City of Portland, Maine – Building or Use Permit Application 389 Congress Street, 04101, Tel: (207) 874-8703, FAX: 874-8716

Permit No: 980577

DATE: 3 June 98 ADDRESS: 21 Castine Ave. (309-D-007)
 REASON FOR PERMIT: To Convert mudroom To Living space -
 BUILDING OWNER: Starhope
 CONTRACTOR: Peter Tierney
 PERMIT APPLICANT: - ↑
 USE GROUP A-3 BOCA 1996 CONSTRUCTION TYPE 5B

Proposed House

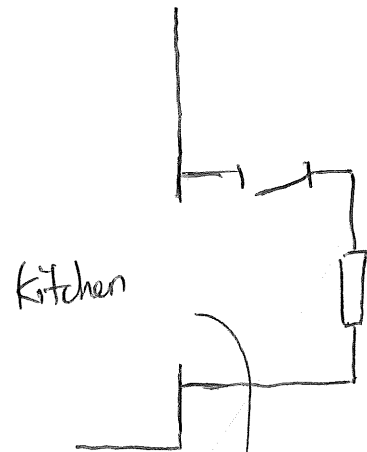
6/11/98 - Spoke w/owner re: 6x8 - span is only 5' so 6x8 ok - will start
wk of 6/15 - sched. Close in wk of 7/13
8/2/99 Completed a Rowe

- X 29. The proposed open in kitchen with 2-2x8" headers can only span 6' of open
30. _____
31. _____
32. _____

plot plan

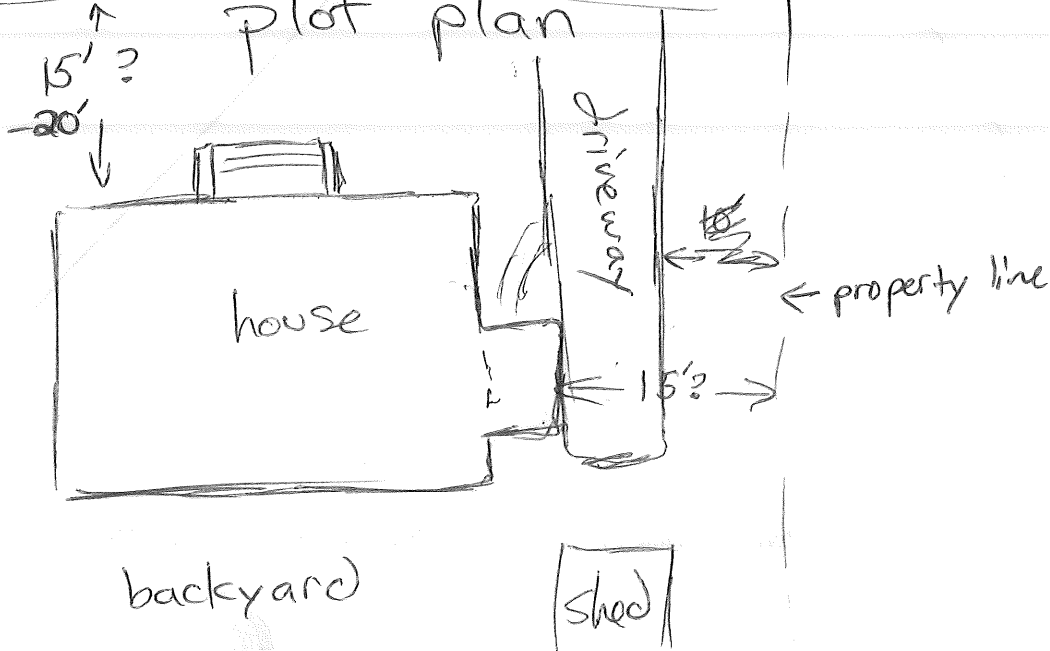
Rear Yard - 25' req - 25' shown

Side Yard - 8' req - 15' shown
